# Product Upgrade Bulletin

**UPGRADE BULLETIN:**  
**160831REV**

Wiring correction to allow recharging of the auxiliary batteries via the alternator

**ISSUE DATE:**  
September 2016

**Figure 2 - Battery Isolator Wiring After Correction**

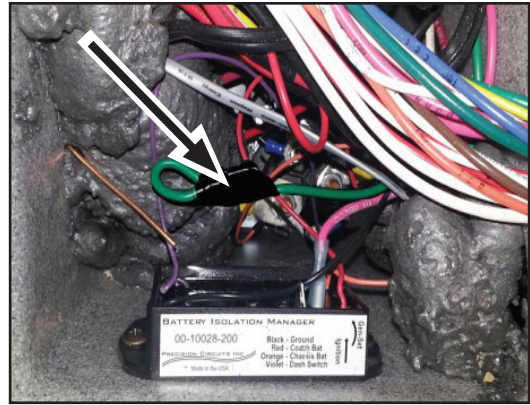
If a green wire (Circuit 529) was installed at the "GEN" terminal on the Battery Isolation Manager, the auxiliary and main battery banks will be isolated while the chassis ignition is turned on; this will prevent the alternator from recharging the auxiliary batteries. Disconnecting the green wire from the "GEN" terminal will enable the chassis alternator to charge the auxiliary batteries.

- 3. Referring to Figures 1 and 2, remove the Green wire (marked 529) from the "GEN" terminal at the Battery Isolation Manger. Apply heat shrink tubing to the end of the disconnected wire. Wrap electrical tape around the heat shrink tubing to complete the procedure.
